CITY OF MOUNTAIN VIEW
RESOLUTION NO.
SERIES 2023

A RESOLUTION OF THE CITY COUNCIL OF THE CITY OF MOUNTAIN VIEW
ADOPTING THE INITIAL STUDY/MITIGATED NEGATIVE DECLARATION FOR
THE TERRA BELLA PUBLIC STORAGE AND ALTA HOUSING AFFORDABLE HOUSING PROJECTS
LOCATED AT 1020 TERRA BELLA AVENUE, 1040 TERRA BELLA AVENUE,
AND 1055 SAN LEANDRO AVENUE PURSUANT TO
THE CALIFORNIA ENVIRONMENTAL QUALITY ACT

WHEREAS, the response to public comments and text modifications to the Initial Study is attached hereto and incorporated herein as Exhibit B; and

FIGURE 3.0-1

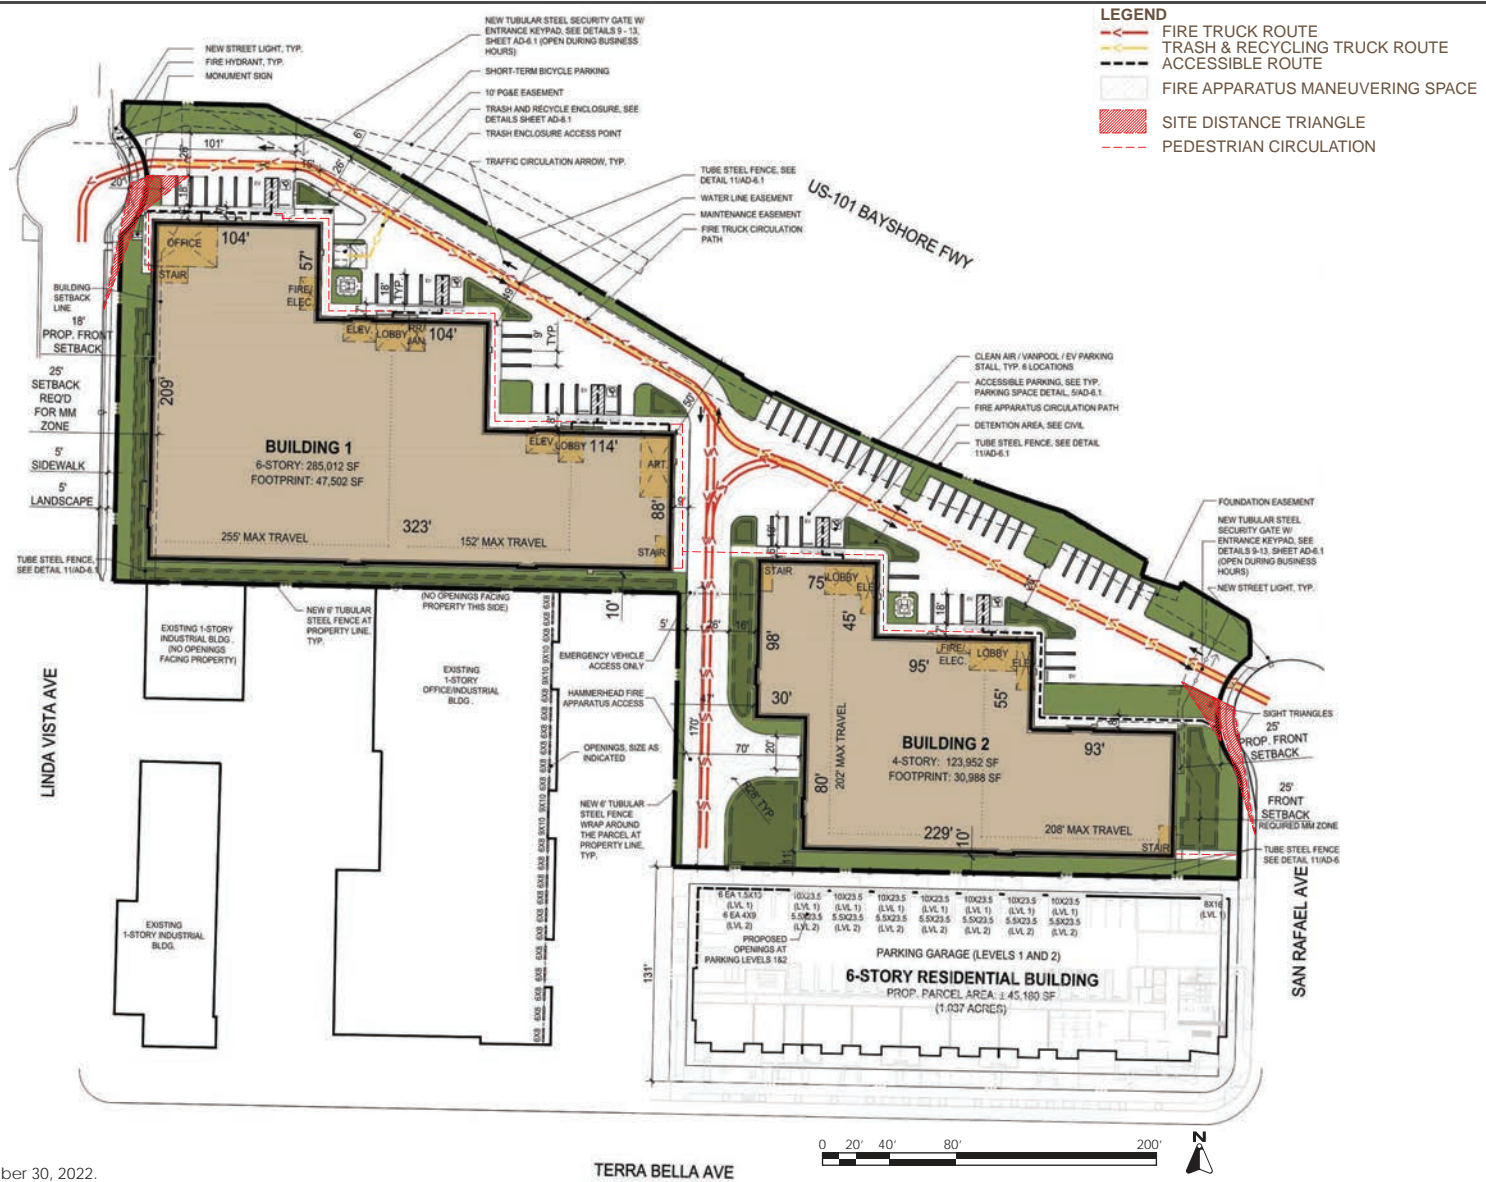
Pages 8 and 10 Draft Initial Study; REPLACE Figure 3.0-1 on page 8 and REPLACE Figure 3.0-3 on page 10 as follows:
